[Docket No. 2003-SW-38-AD; Amendment 39-13686; AD 2004-13-05]

Airworthiness Directives; Eurocopter Deutschland Model MBB-BK 117 A-1, A-3, A-4, B-1, B-2, and C-1 Helicopters

ACTION: Final rule.

2004-13-05 Eurocopter Deutschland: Amendment 39-13686. Docket No. 2003-SW-38-AD.

Vertical Fin-Skin Panelling
Figure 1

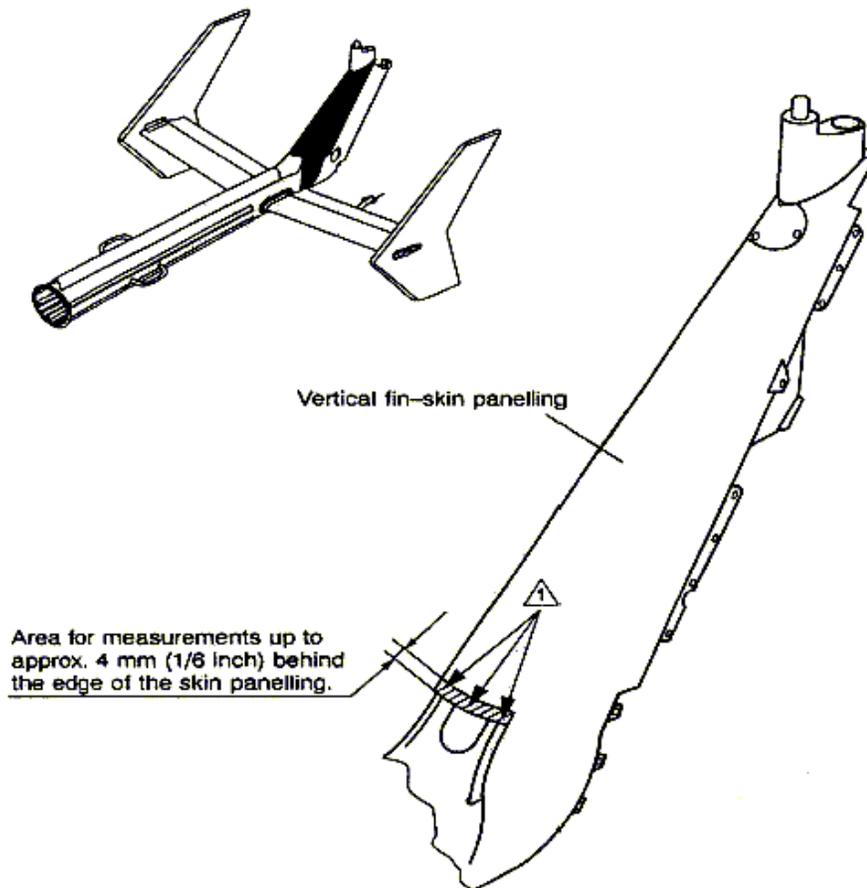
(a) Using external calipers, measure the wall thickness, including primer coating, of the skin paneling of the vertical fin at the locations shown in Figure 1 of this AD.

△ Measurements are to be taken at at least three locations on the skin panel of the vertical fin. Care has to be taken that the external calipers are held squarely to the skin panel wall while measurements are being taken, since tilting of the calipers can lead to false results. If the panel thickness, including the primer coating, is at least 0.778 mm (0.03063 inch) at every measured location, no further action is necessary.

(b) If the wall thickness, including the primer coating, of the panelling is less than 0.778 millimeter (0.03063 inch) at any of the measured locations, replace the vertical fin with an airworthy part before further flight.
